35/36-01A 5806 Warwick Place R
(Somerset Historic District)

FAX TRANSMITTAL SHEET

12 September 2001

RE: Hughes/Stern Residence
5806 Warwick Place
Permit No. 238984

Sketch: Currently Proposed Street Facade
Date: 12 September 2001

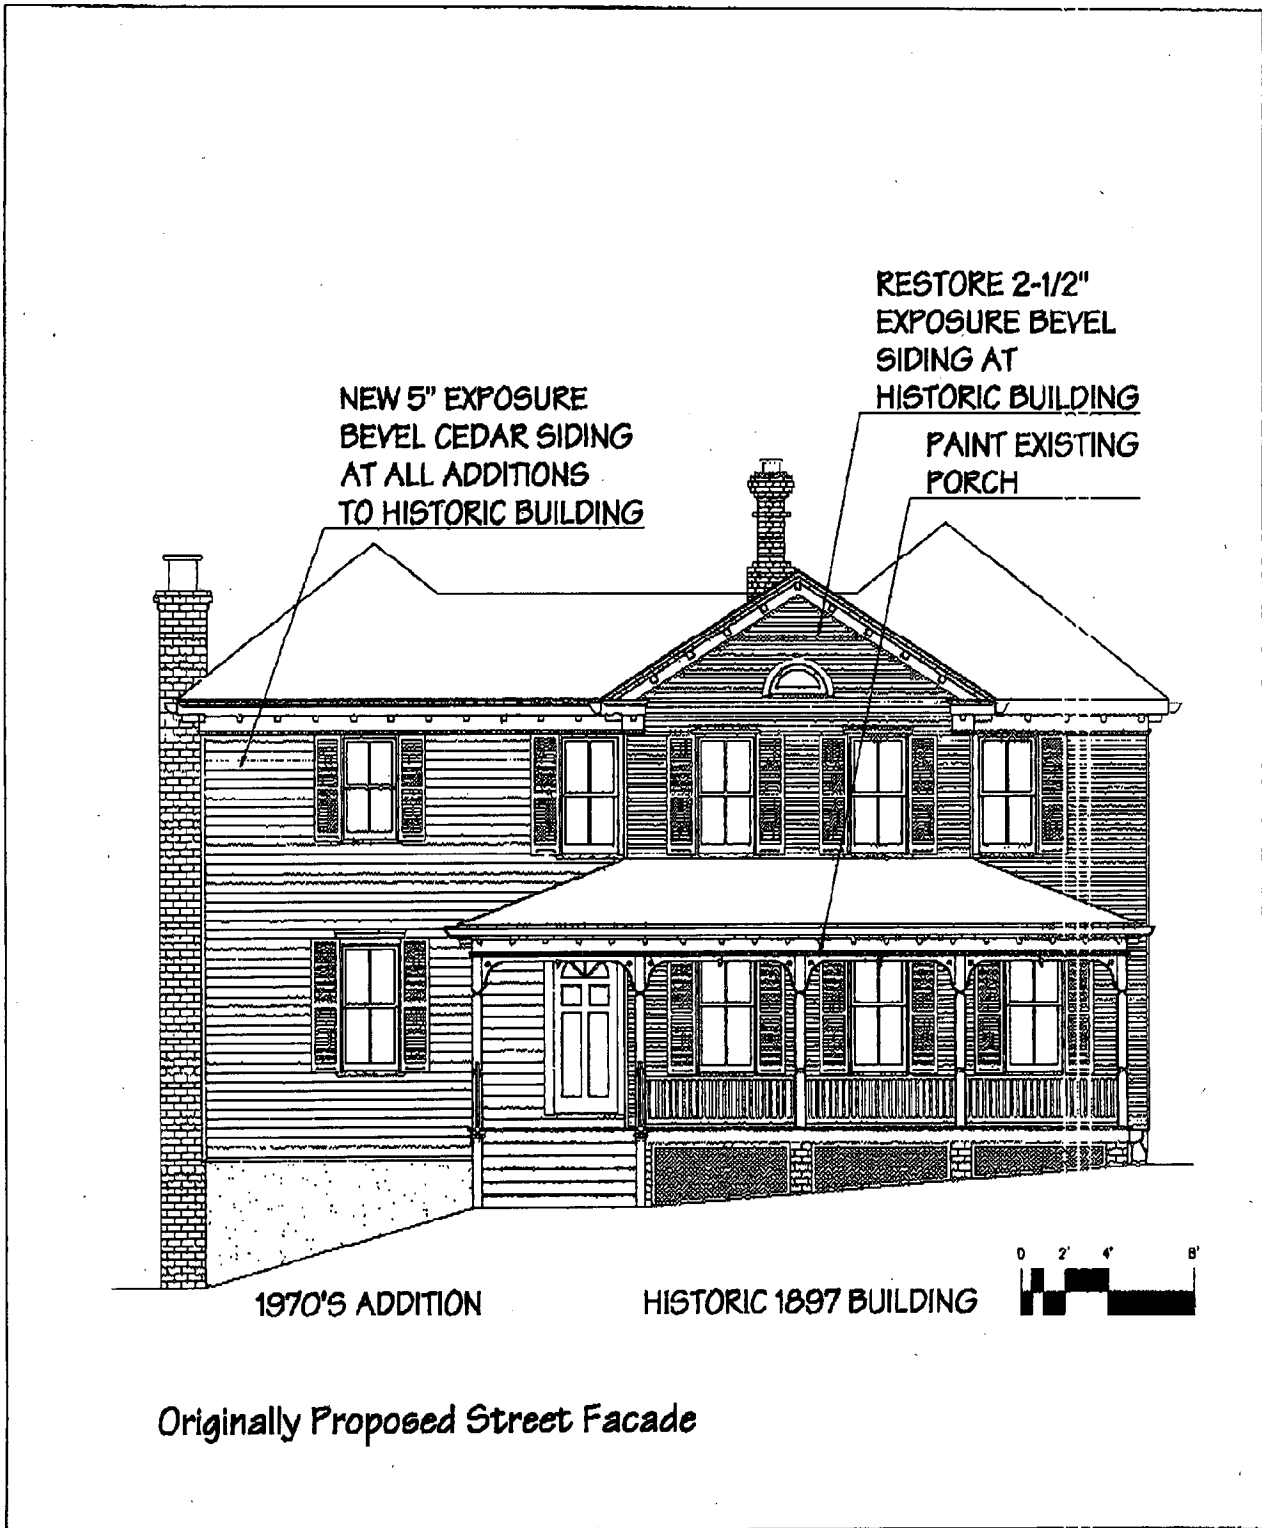
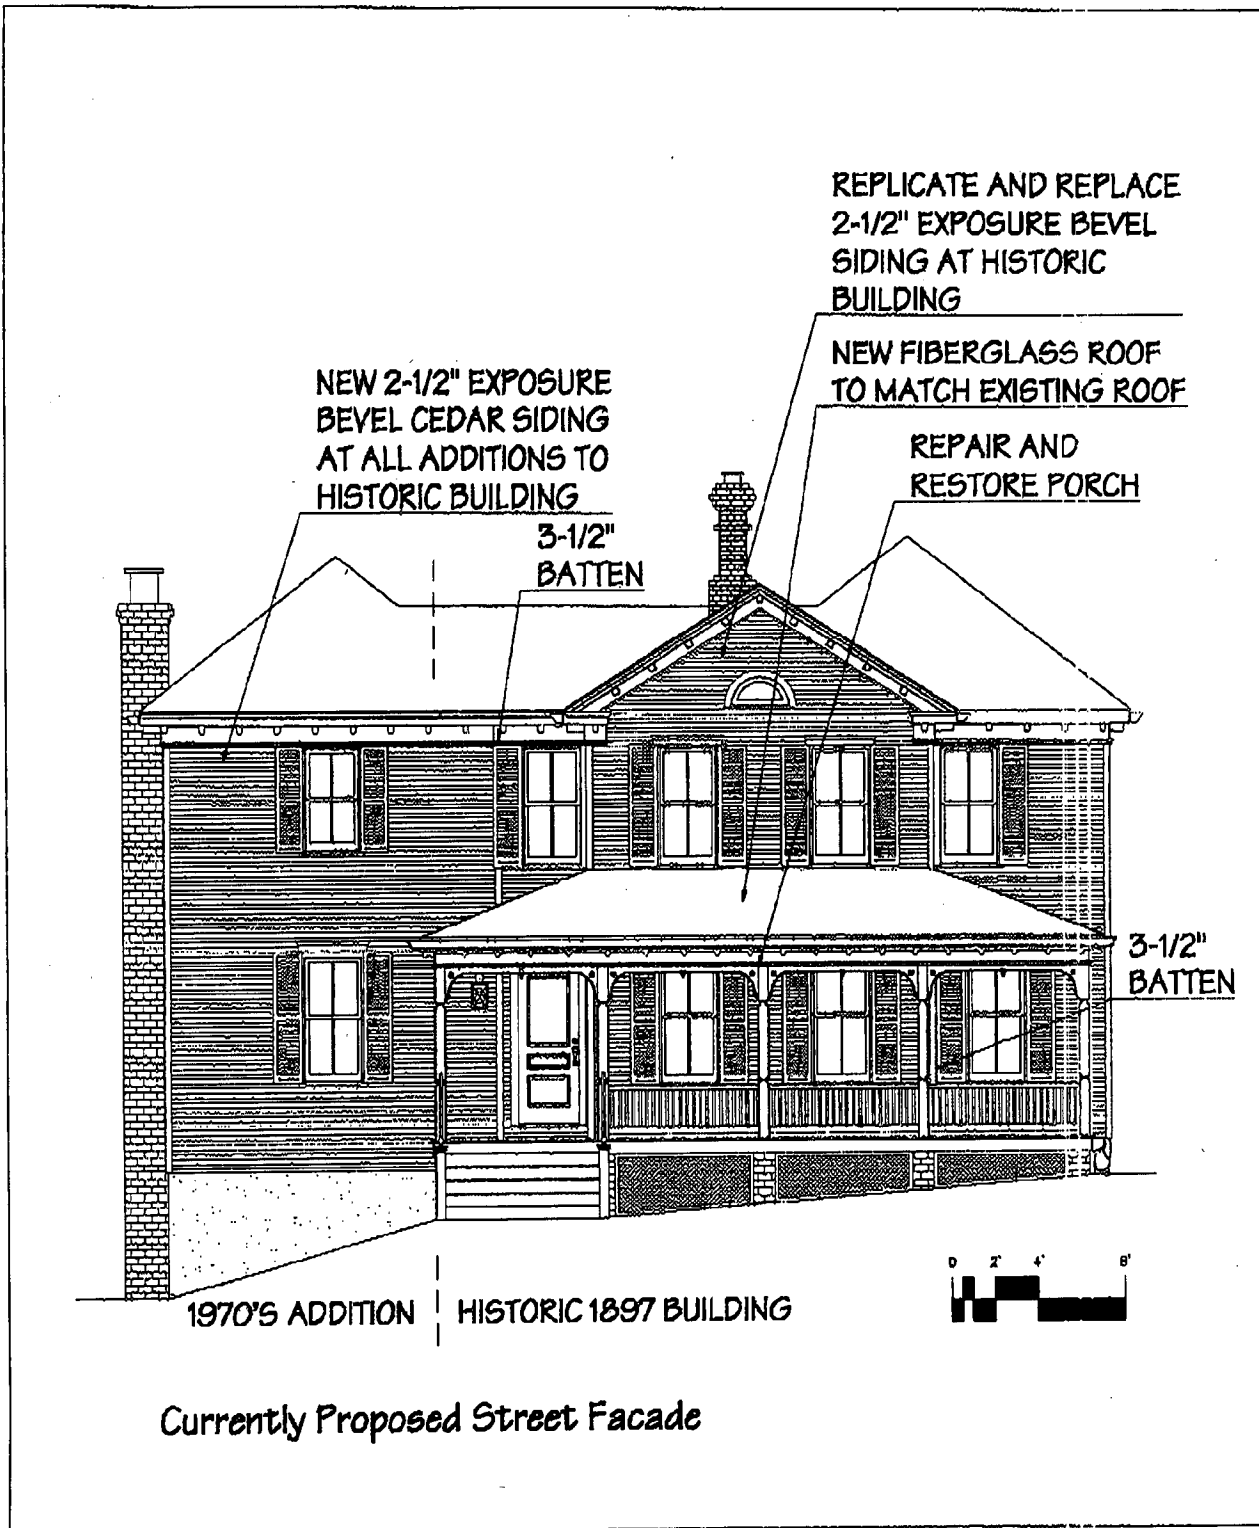
2. Installation of siding on the new addition to match the existing narrow exposure siding profiles.
The second issue relates to the new siding to be used on the former addition and the new addition that we have designed. We originally proposed to double the exposure on the new portion to contrast it with the original house. As you can see from the attached sketches, our original proposal did not clearly define the line between the old and new. The original house extended to the line of the porch columns. After seeing the house with the original siding, we began to reconsider our decision to contrast the exposure and would like to seek approval for installing a similar exposure siding on the new additions with a vertical batten to delineate the historic building from the newer additions on the street façade only. The only other intersection between old and new, along the right side, is clearly delineated by a setback of the new building and by a contrasting stucco foundation wall. A sketch of the originally proposed front façade is attached, along with a sketch of the currently proposed solution.

The other houses of similar period on Warwick Street all have narrow exposure siding for both the new and the original siding, and we feel that this approach will be more sympathetic with the street, while more accurately delineating the edge of the original house. Unlike some of its neighbors, 5806 Warwick Place will have a very clear demarcation between new and old. The use of vertical battens where the new and old portions meet, by the change in the foundation from stone to stucco, and the clear offset in plane along the North side all provide a clear line between old and new.

We propose to use the same narrow exposure lap siding of the identical profile as the original for all new work and use the change of plane and vertical batten at the intersection of the new and the original portions of the house. We believe this is more consistent with the other houses on the block and more aesthetically pleasing, while preserving the distinction between old and new.
